From: Hoellman, Jordan
Sent: Thursday, April 07, 2016 12:59 PM
To: Vogtle PEmails
Subject: Qualitative impact assessment on the Vogtle global seismic model due to proposed changes to Wall N (LAR-131) --UPDATED--
Attachments: DCP-5248_Impacts to Seismic Analysis_Due to Wall N +4in__04-04-2016 WEC 2016-04-07.docx

Proposed change of DCP 5248, Rev. A (Applicable to only plants SV3, SV4):

Change Tier 1 Table 3.3-1 wall thickness tolerance from +1” to +4” for Column Line N Wall from Column Lines 2 to 4 (44 feet) from Elevations 98’-1” to 135’-3.”

Figure 3H.5-1 (Sheet 1 of 3)
[Nuclear Island Critical Sections
Plan at El. 135'-3"]

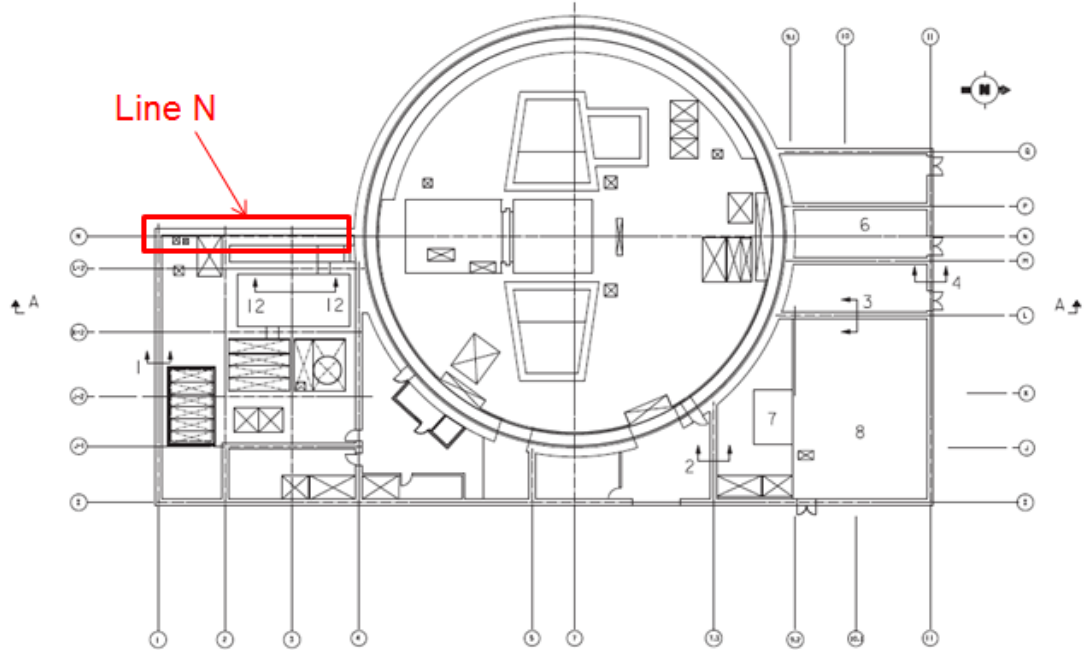
Wall N:

The proposed change does not have an adverse impact to the Vogtle site specific nuclear island seismic analysis or the design response spectra for Vogtle based on the following reasons:

- Considering a +4” tolerance for the 66” thick wall results in a maximum of only 6% increase in mass for this local area of the nuclear island compared to the nominal dimensions. The increase in mass is negligible compared to the total mass of the nuclear island, and will not result in a sizeable change to the dominant modes of the structure.
- The change to the local region of the nuclear island is relatively small, and will not result in a significant change in structural response in this local area or adjacent areas.
- The seismic response spectra generated as input to structures, systems, and components is broadened by +/-15 percent to account for variations in structural frequencies due to uncertainties in parameters such as material and mass properties of the structures and the soil, damping values, seismic analysis technique, and the seismic modeling technique.
